Patagonia Area Resource Alliance (PARA) ♦ Arizona Mining Reform Coalition ♦
Borderlands Restoration Network ♦ Center for Biological Diversity ♦ Earthworks ♦
Friends of the Santa Cruz River ♦ Friends of Sonoita Creek ♦ Sierra Club (Grand
Canyon Chapter) ♦ Tucson Audubon

January 12, 2024

**Re: Comments and Objections to Proposed Renewal of AZPDES Permit
(AZ0026387) for South32 Hermosa, Inc.**

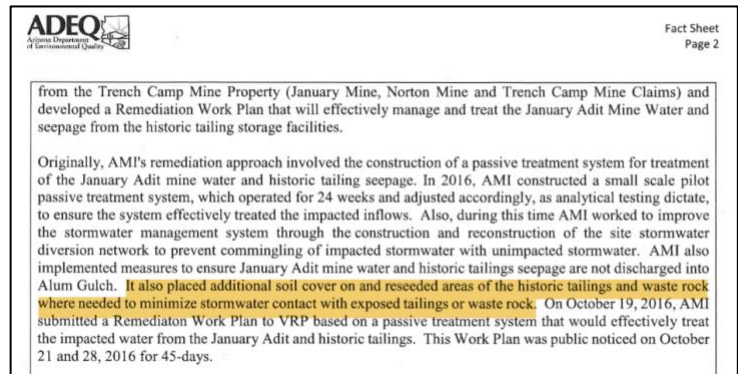
In a clear effort to avoid the TMDL and other requirements discussed above applicable to discharges from Outfall 001 into impaired Alum Gulch, ADEQ includes the following prohibition in the Draft Permit at Part I(A)(1)(b) that ADEQ’s own materials demonstrate is untethered from reality: “The only allowable discharges from Outfall 001 are drainage water from historic workings associated with the January Adit, drainage water from historic tailings, and stormwater. See definition of ‘historic’ in Appendix A, Part B of the Draft Permit. If South32 does seek to add dry stack tailings from a future mill to the existing tailings storage facility, they must notify ADEQ and cease discharge to Alum Gulch.” The Draft Fact Sheet (below) contains similar language.

ADEQ states that these restrictions are to ensure “that no new sources will be discharged to an impaired water as required by the *San Carlos* decision.” (Draft Fact Sheet at 6).²⁷

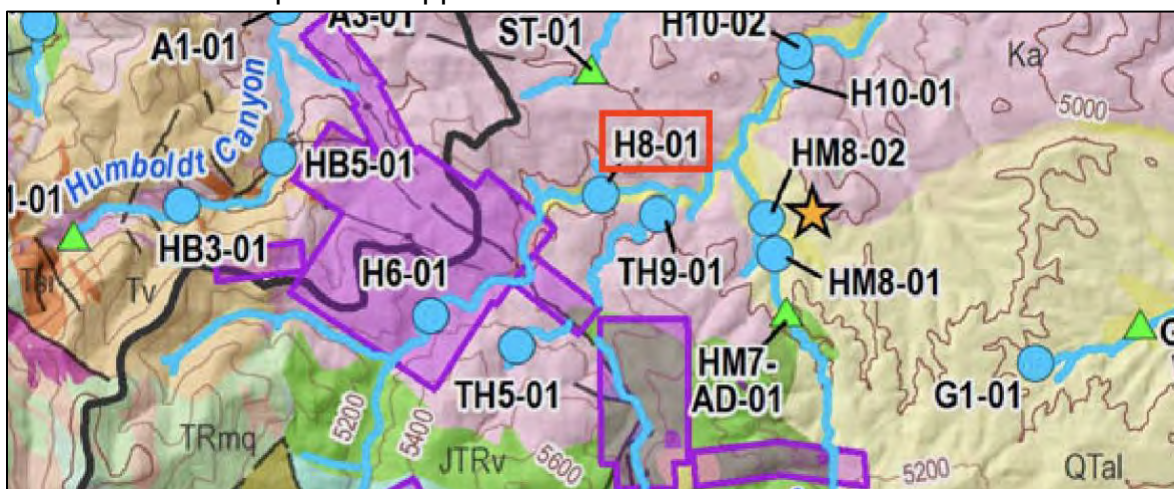
Consistent with the TMDL written description, the map excerpt below (from 2003 Upper Harshaw Creek TMDL at [p.18](#), color annotations added), shows the bottom portion of the listed reach extending past Trench Camp Mine, beyond ADEQ Sample Point No. SCHRC011.56, and ending after the spring. Although the 2003 Upper Harshaw Creek TMDL does not include the exact length of this bottom reach of Upper Harshaw, it extends beyond these tangible points.

Below - Figure 2 from South32 (formerly Arizona Minerals)’s Application for Reissuance of AZPDES Permit dated July 11, 2022 (annotations added). Outfall 002 is south of (upstream of) H8-01.

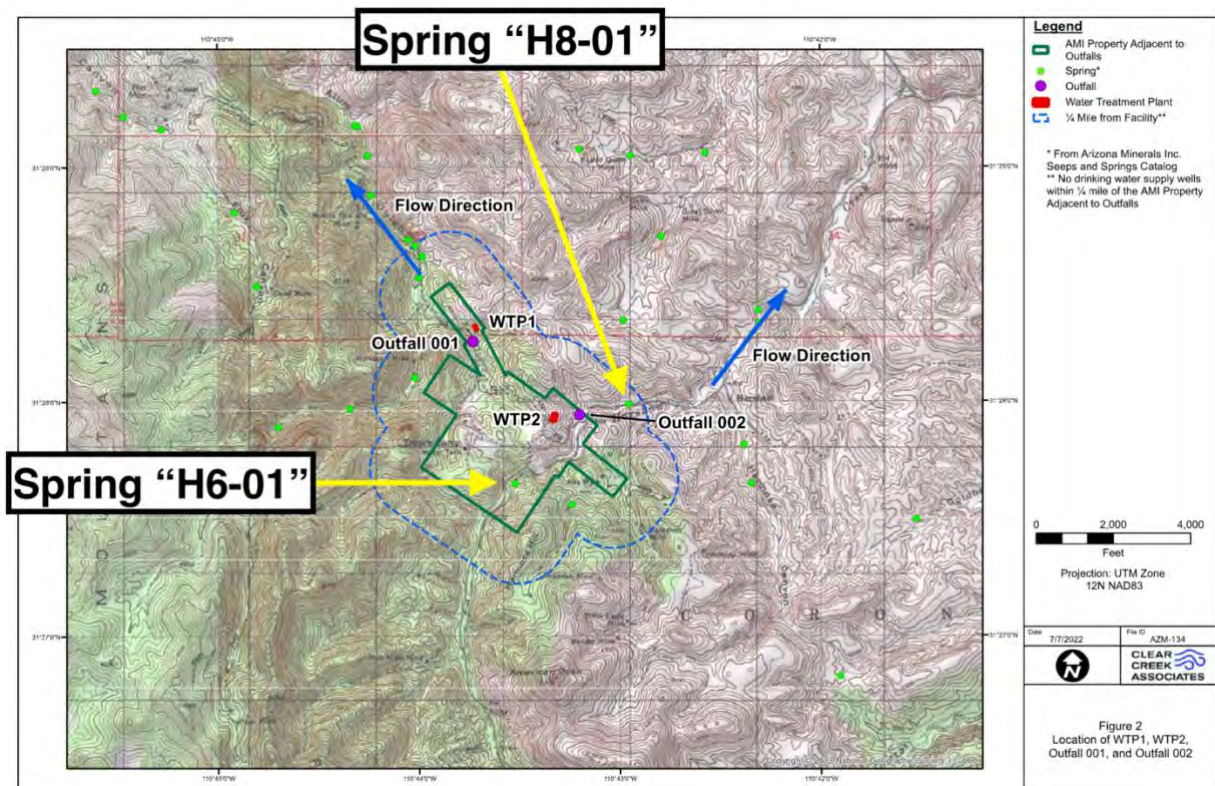
First, H6-01 is located south of sample point SCHRC011.56, which directly conflicts with the TMDL maps and descriptions of the end point spring. While the TMDL correctly documents the presence of more than one spring in this area (which is supported by the map above),⁹ only one spring is noted in the TMDL as marking the end of Upper Harshaw Creek. And the TMDL indicates this spring is located much further north than H6-01.

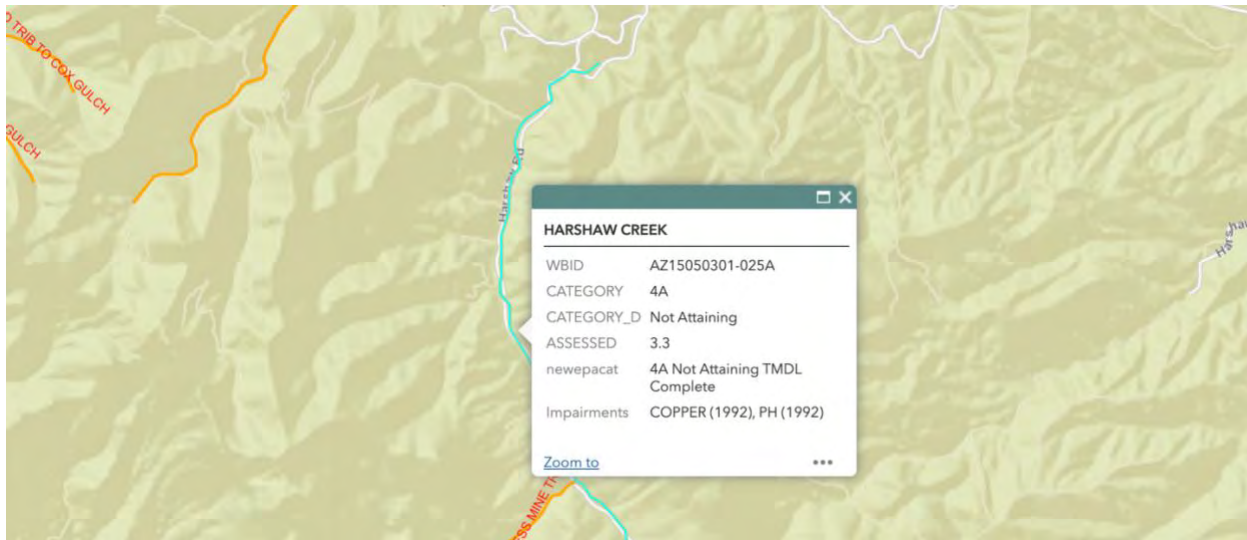
PARA has been unable to locate any basis for ADEQ’s convenient contraction of the apparent extent of “Upper Harshaw Creek” to just above Outfall 002. These specific coordinates are absent from the text of ADEQ 2003 Upper Harshaw Creek TMDL. They are also absent from all associated TMDL materials obtained and reviewed from that time, and their origins are presently unclear. So far, they only appear in materials dating after the TMDL was completed. In addition, PARA has been unable to locate any information to justify this apparent (*de facto*) “removal” of the bottom extent of Upper Harshaw Creek from the CWA 303(d) list, if this is, in fact, ADEQ’s intent.

This point is illustrated when ADEQ’s recently-generated end coordinates are plotted on a map (as shown in [ADEQ eMap](#), Impaired Streams 2022 layer, below), they very plainly conflict with what ADEQ’s 2003 TMDL describes and identifies as the end of the bottom portion of the impaired reach – marking the end of the impaired reach sooner than the TMDL indicates.

Figure 15. AMI's delineated Discharge Impact Area and Pollutant Management Area for the Hermosa Project (Clear Creek Associates, 2020).

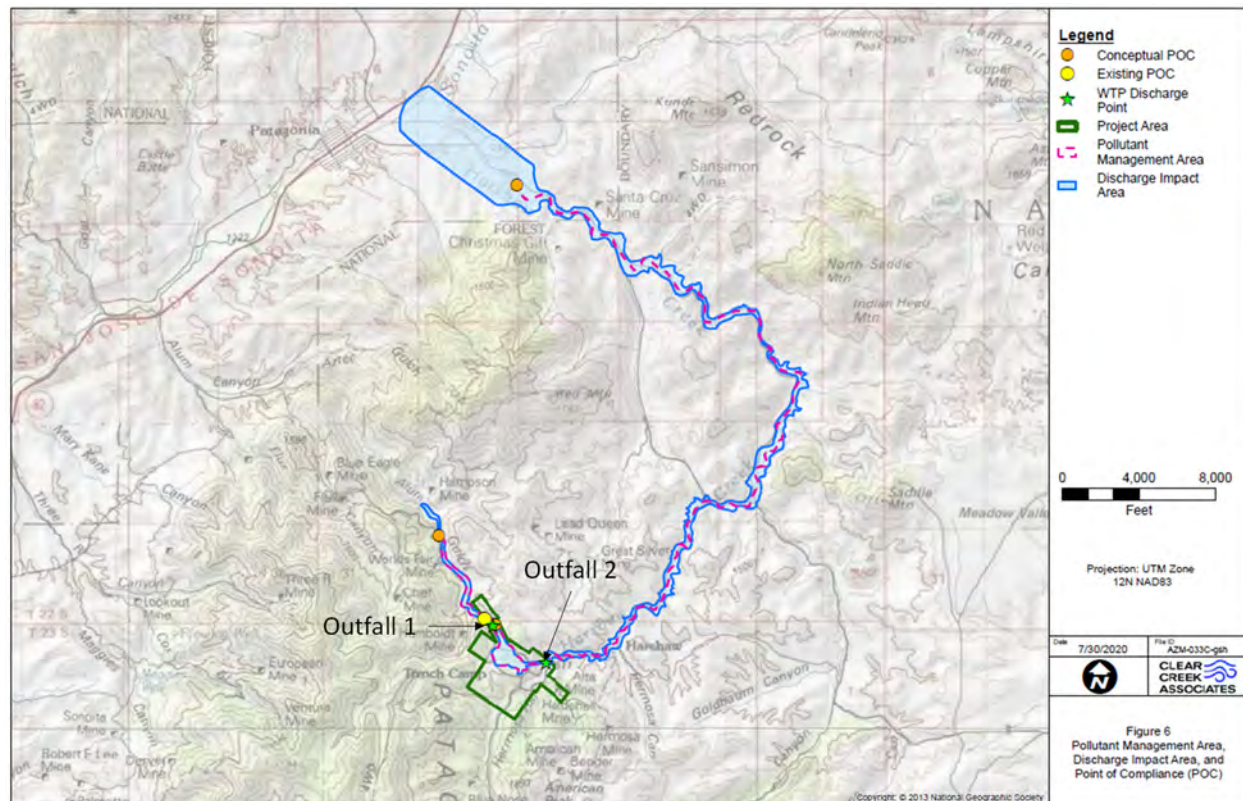
This 9.4-mile distance became the basis for AMI's delineated "Discharge Impact Area (DIA)" and "Pollutant Management Area (PMA)" (Figure 15) downstream of WTP2 (Clear Creek Associates, 2020). The authors of the DIA and PMA delineation study used an analytical (vs. physical) model and note that, "... the analysis does not assess transient events or changes in streambed or aquifer storage over time" (Clear Creek Associates, 2020, p.18).

Figure 20. Simulated discharge at the TNC Patagonia-Sonoita Creek Preserve with and without 4 years of 4500 gpm discharge at WTP2.

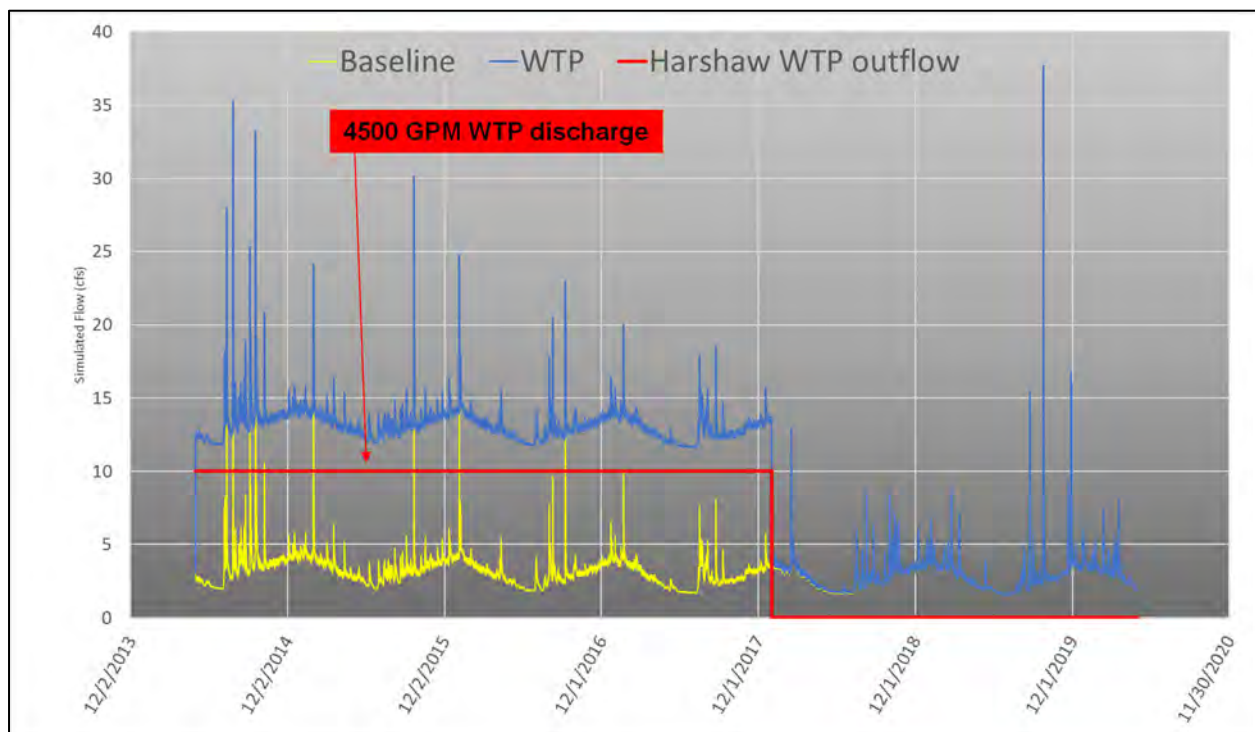
Figure 20 illustrates simulated discharge at the TNC Patagonia-Sonoita Creek Preserve under baseline conditions (yellow) and with 4500 gpm of discharge from WTP2 for roughly four years. This graphic shows that after only a little over a month of wetting up the channel and local aquifer system, the added WTP2 discharge is conveyed with virtually no loss (not accounting for evapotranspiration increases over time) from WTP2 through town and down to the TNC preserve. The size of the storm peaks with the additional WTP2 discharge is augmented due to the lack of unsaturated zone storage capacity resulting from shallow groundwater and shallow bedrock in Harshaw Creek; thus storm flows are “rejected” from the groundwater system rather than being able to infiltrate the way they could under baseline conditions. This hydrologic behavior is supported by Schrag-Toso’s (2020) assessment that, “...the thin veneer of stream channel sediments appears to be a conduit of groundwater flow, moving groundwater discharged from the fracture system mixed with recent precipitation towards the Sonoita Creek basin.”

Figure 22. Overlay of AMI's "Discharge Impact Area" (Clear Creek Associates, 2020) on map of groundwater wells (red triangles) and groundwater elevations (Lacher & Prucha, 2020). Yellow arrow shows flow path into and down Sonoita Creek toward the TNC Preserve.

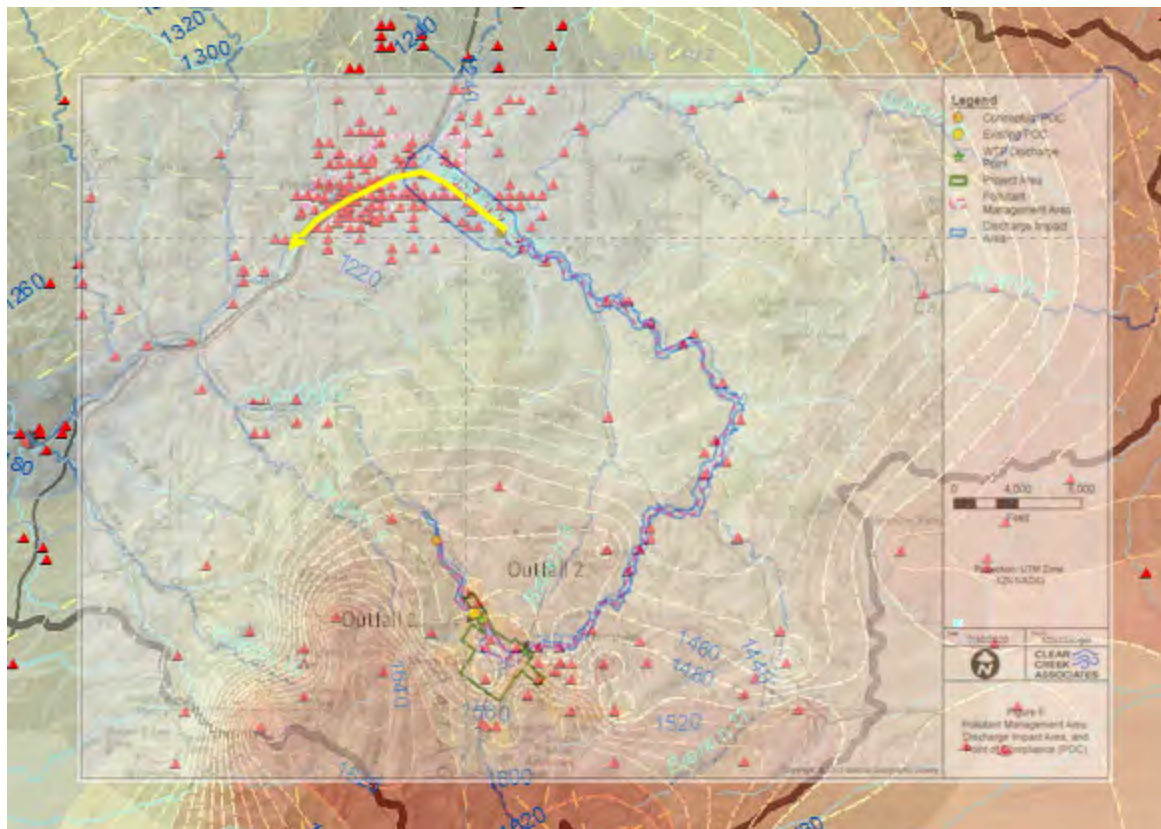
Any contaminants conveyed by Harshaw Creek surface and groundwater flows will now have more immediate contact with the Sonoita Creek alluvial aquifer which is the primary source of drinking water for Patagonia residents. Well owners along Harshaw Creek will likely experience increased groundwater levels and potentially increased contaminant levels associated with the WTP2 discharge. The potential for WTP2 discharge to impact drinking water wells is unquestionable. AMI's consultant used the Theis equation (Theis, 1935) to calculate a groundwater 30-year travel distance to the northwest of the "anticipated end of surface flow" shown in Figure 15 as 7,227 ft (Clear Creek Associates, 2020). This would put any groundwater recharge from the WTP2 roughly 500 ft above the Sonoita Creek confluence, and well within the range of numerous local wells. However, the MIKESHE model suggests a very different system response, with flows from WTP2 reaching the TNC preserve downstream of the Town of Patagonia within several weeks of the initiation of 4500 gpm flows. Figure 22 illustrates AMI's delineated "Discharge Impact Area" (DIA) overlain on a map of groundwater wells used to define groundwater elevations for the MIKESHE model. This is a subset of all wells in the area. Notably, there are many wells within the entire length of the DIA up Harshaw Creek and south of Outfall 2.
